# Pyrmont Peninsula Sub- Precinct Master Plans

SUBMISSION

1 April 2022

# Blackwattle Bay Sub-Precinct

**Figure 1 - Opportunities for Alternative Sea-level Protection**

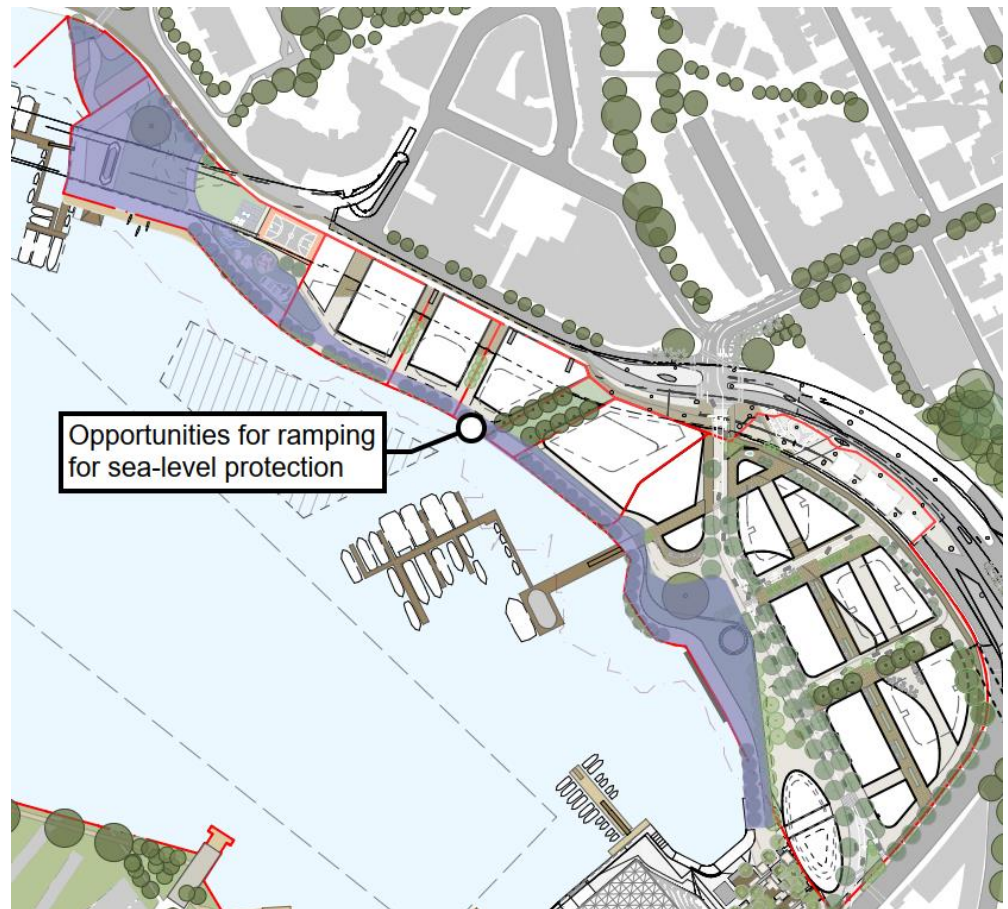
For the broader development, there are several different flood strategies that could be employed if the promenade was not to be constructed. These include maintaining the existing seawall levels and ramping up from these points towards the internal road network and building façades, as shown in Figure 1.

There is currently a significant amount of proposed open space between the existing seawalls, the proposed buildings and road network that could allow for this ramping to occur along with ample opportunity for the new buildings to be set at a level accounting for sea level rise without increases to the existing seawall height.
